NOTTING HILL

SUBMISSION MASTER DEVELOPMENT PLAN

Re: **Notting Hill**

MDP # 008-07

MP-6

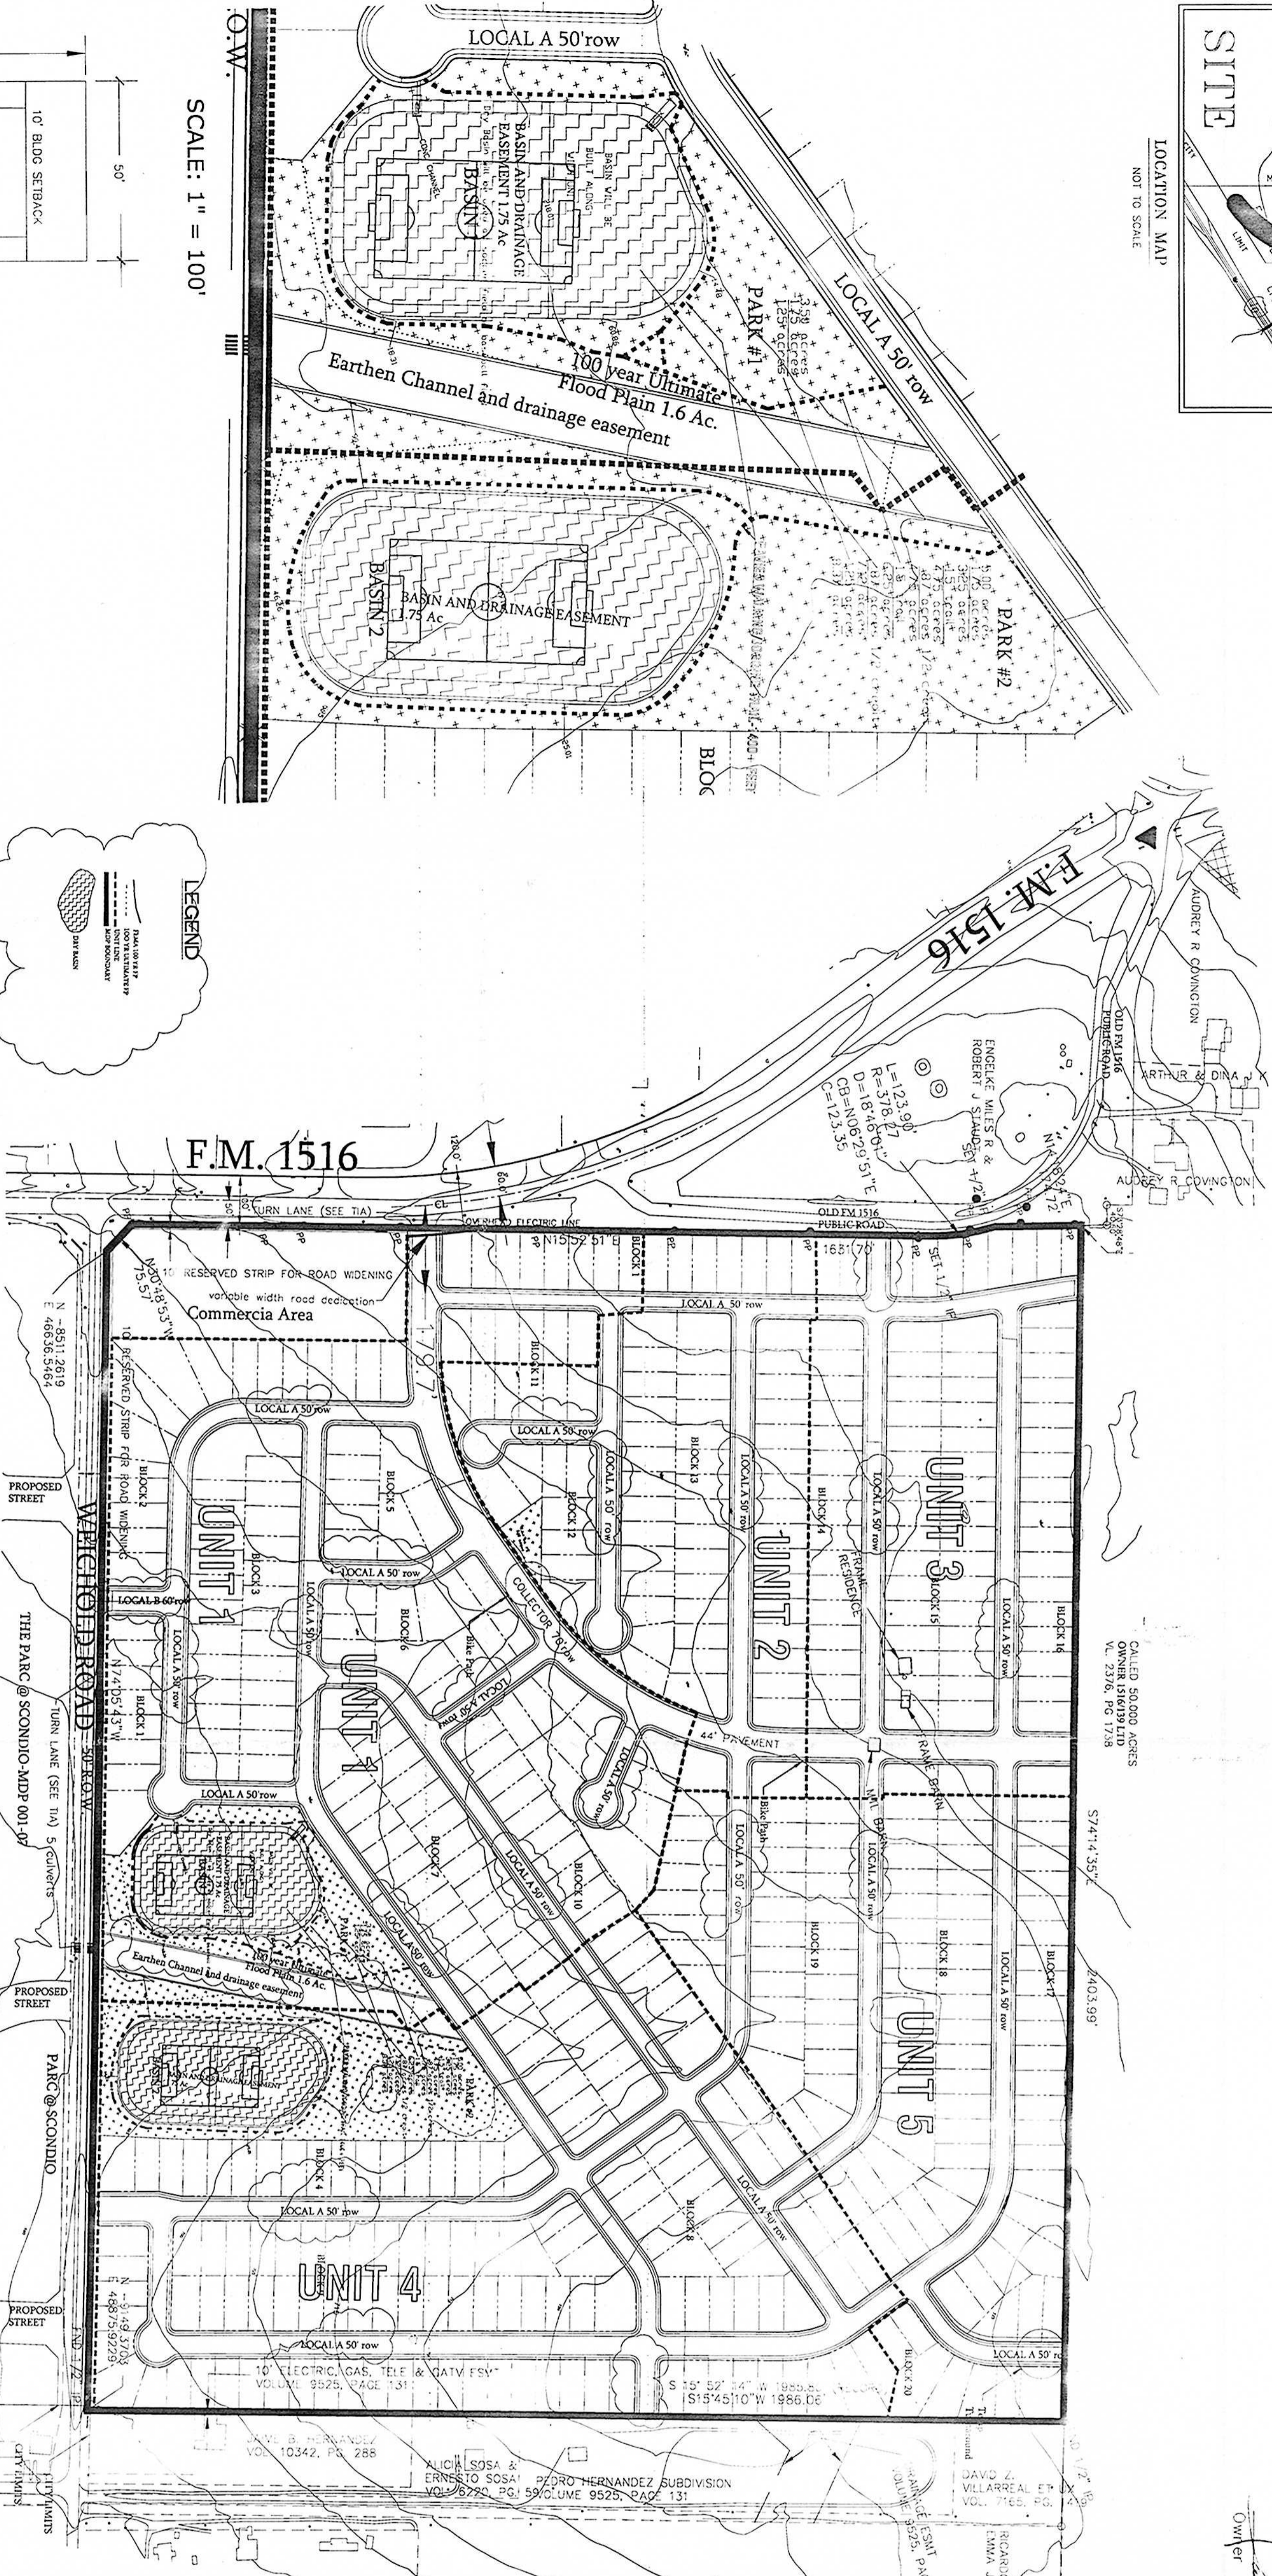
The Texas Sites Atlas indicates that no archaeological/architectural sites have been previously identified within the above referenced property. However, staff of the OHP believes there is a **high probability** that the property may contain sites, some of which may be significant. An historic agricultural complex may be located within the project area. Thus, before any work that might affect any sites is begun, we recommend that a qualified professional conduct an archaeological/architectural investigation of the property. The investigation should be performed according to Archeological Survey Standards for Texas, and any previously identified sites should be reexamined and reevaluated, if any. A list of qualified archaeological consulting firms is available on line at www.c-tx-arch.org. The consultant may need to obtain an antiquities permit from the SHPO prior to starting the investigation. A report of findings should be prepared according to the Council of Texas Archeologists [CTA] Guidelines for Cultural Resource Management Reports and submitted to the HPO and SHPO for review. Copies of the survey standards and the CTA guidelines may be obtained by calling the SHPO at 512-463-6096 or writing to P.O. Box 12276, Austin, Texas 78711-2276. Law allows both the HPO and SHPO 30 days from receipt for reviews.

- Coordinate mitigation improvements for the following intersections with TXDOT:
 1. FM 1516 and old FM 1516
 2. FM 1516 and Weichold – traffic signal warrants analysis.
- Construct right turn deceleration lanes at the following intersections:
 1. Northbound FM 1516 and Roadway A.
 2. Westbound Weichold Road and Roadway B.
 3. Westbound Weichold Road and Mission Trail (developer option).
- Construct left turn lanes at the following intersections:
 1. Westbound Weichold Road and F.M. 1516.
 2. Eastbound Weichold Road and Roadway B.
 3. Eastbound Weichold Road and Mission Trail (developer option).
- Coordinate the need for acceleration lanes with TXDOT at the following locations:
 1. IH 10 eastbound frontage road and Nieto Drive.
 2. IH 10 eastbound frontage road and Weichold Road.
- All turn lanes shall be designed using TXDOT's standards and specifications.

The park dedication requirement for this development is 7.40 acres. This development provides 4.5 acres of acceptable park/open space. Torres Engineering, P.C. submitted a Conditional Letter of Map Revision (CLOMR) to FEMA April 20, 2007. 4.5 acres of park open space dedication is currently located within the 100 year floodplain, however according to this letter if the proposed project is constructed as shown on topographic work map entitled "Floodplain Exhibit for Nothing Hill Subdivision," dated October 2006, a revision to the FIRM would be warranted. The engineer is providing a drainage easement which will alter the floodplains location ultimately creating a non-floodplain area for these dedicated 4.5 areas of open space. An additional 3.50 acres located in the basin will be credited at 50% (1.75 acres credit) along with a walking/jogging trail providing 2.25 in Park facilities credit, totaling 8.5 acres. Parks staff will ensure park dedication requirements are met as the plats are submitted for review per phase. Any changes to these dedicated areas must be submitted to Parks for review and approval.

It is understood that this is a conceptual plan. Controlled access should be maintained in order to uphold safe and efficient traffic flow and all access shall comply with the requirements of the Unified Development Code and shall be within the guidelines of the American Association of State Highway and Transportation Officials. Bexar County reserves the right to address all design issues including, but not limited to, secondary access, driveways, street design, sight distance, ADA requirements, drainage and floodplain issues at the time of platting.
